Sundry ID: 2838096

Type of Action: APD Change

Procedure Description: XTO respectfully requests approval to make the below listed changes to the approved sundries. 1. Casing design to be changed from the “4-String Design – Engineered Weak Point” (FIGURE F) to the “4-String Design – Open 1st INT x 2nd INT Annulus” (FIGURE D). An open annulus will be utilized and monitored during completions operations. Post completion, bradenhead squeeze will be performed to tie back the 1st intermediate x 2nd intermediate annulus. TOC will be placed into the 1st intermediate shoe but still below the base of Potash interval. 2. No changes to the cementing, casing or mud circulating system designs will be required for the requested change. 3. There is no new surface disturbance. Please refer to the R-111-Q well bore diagrams in the attachment below reflecting the changes requested. WELL NAME API Number JRU Apache Federal Com 111H 30-015-56010 JRU Apache Federal Com 801H 30-015-56011 JRU Apache Federal Com 901H 30-015-55834 JRU Apache U Federal Com 704H 30-015-56188 JRU Apache Federal Com 705H 30-015-56229 There is no new surface disturbance.

WELL NAME	API Number
JRU Apache Federal Com 111H	30-015-5

[Figure F] 4 String – 2nd Intermediate casing engineered weak point

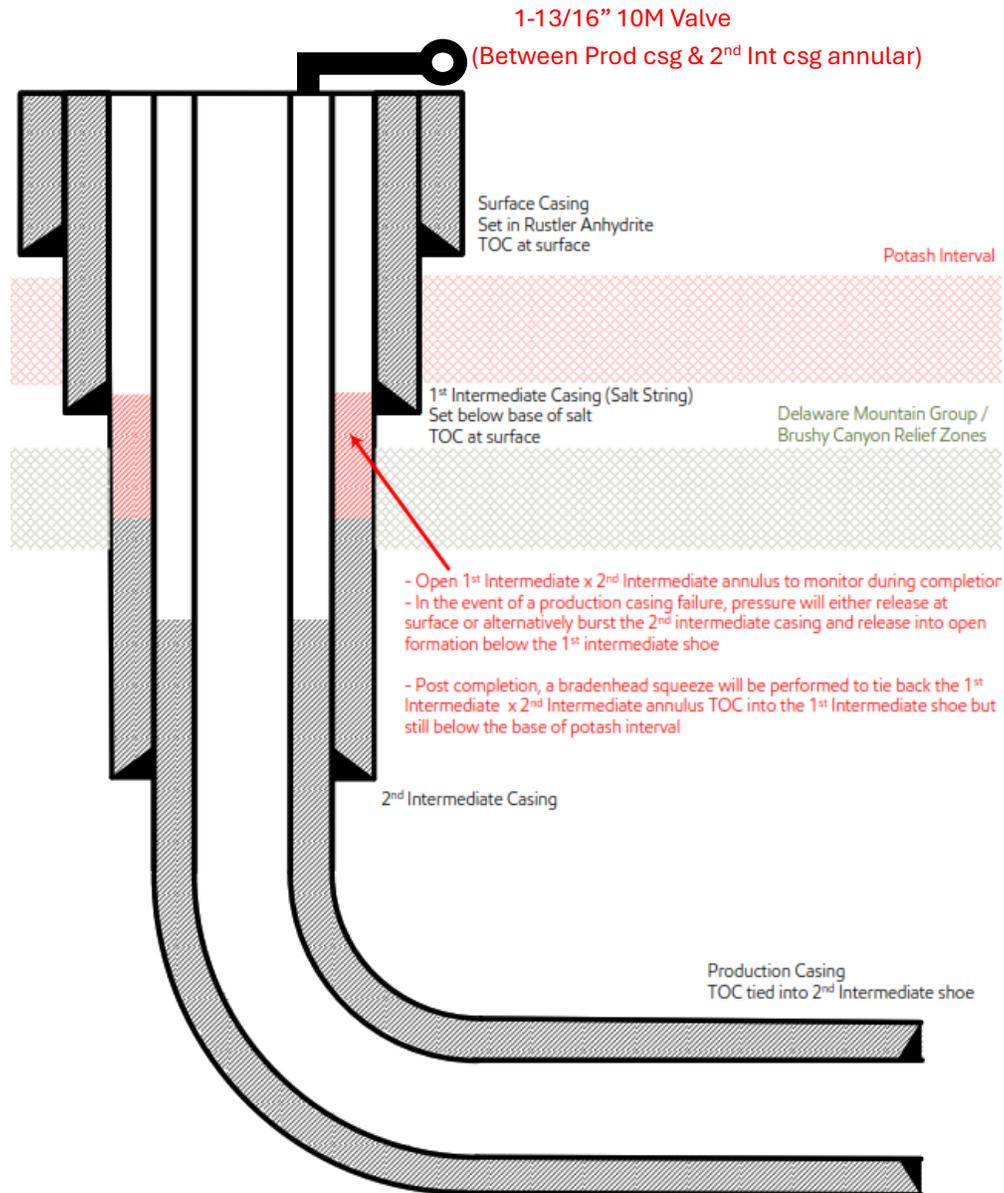
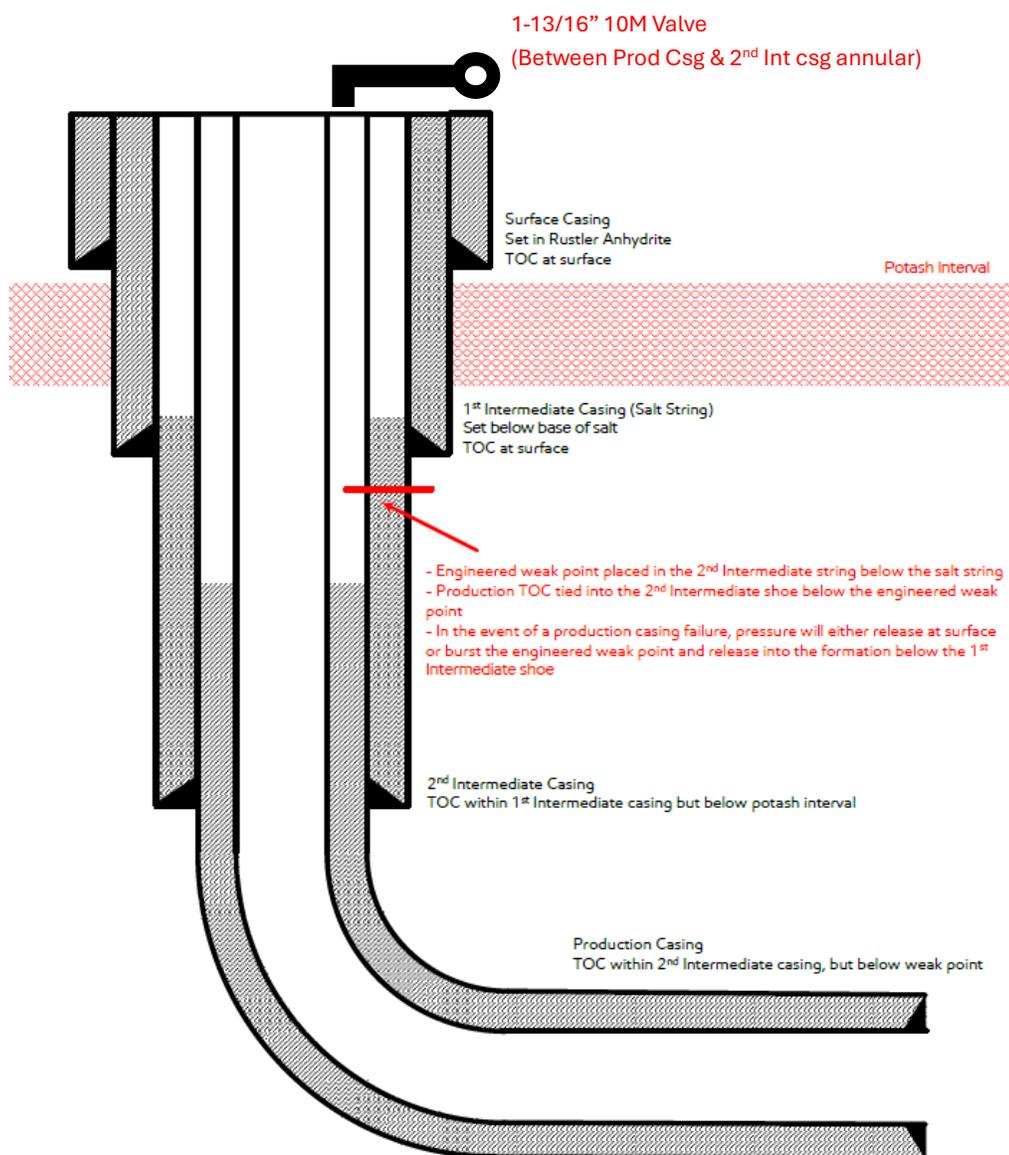
1. Casing design to be changed from the "4-String Design – Engineered Weak Point" (FIGURE F) to the "4-String Design – Open 1st INT x 2nd INT Annulus" (FIGURE D). An open annulus will be utilized and monitored during completions operations.

Post completion, bradenhead squeeze will be performed to tie back the 1st intermediate x 2nd intermediate annulus. TOC will be placed into the 1st intermediate shoe but still below the base of Potash interval.

2. No changes to the cementing, casing or mud circulating system designs will be required for the requested change.

Previous Design: 4-String Design – Engineered Weak Point

New Proposed Design: 4 – String Design – Open 1st Int X 2nd Int Annulus (ICP 2 below relief zone)**[Figure D] 4 String – Uncemented annulus between 1st and 2nd intermediate casing strings**

- 1) Alignment with KPLA requirements per schematic above, leaving open annulus open for pressure monitoring during frac and utilizing new casing that meets API standards.
- 2) Contingency plans in place to divert fluids away from salt interval in event of production casing failure.
- 3) Intermediate 2 bradenhead squeeze to be completed within 180 days to tieback TOC to salt string at least 500ft but with top below Marker Bed 126.
- 4) Production cement to be tied back no less than 500ft inside previous casing shoe.
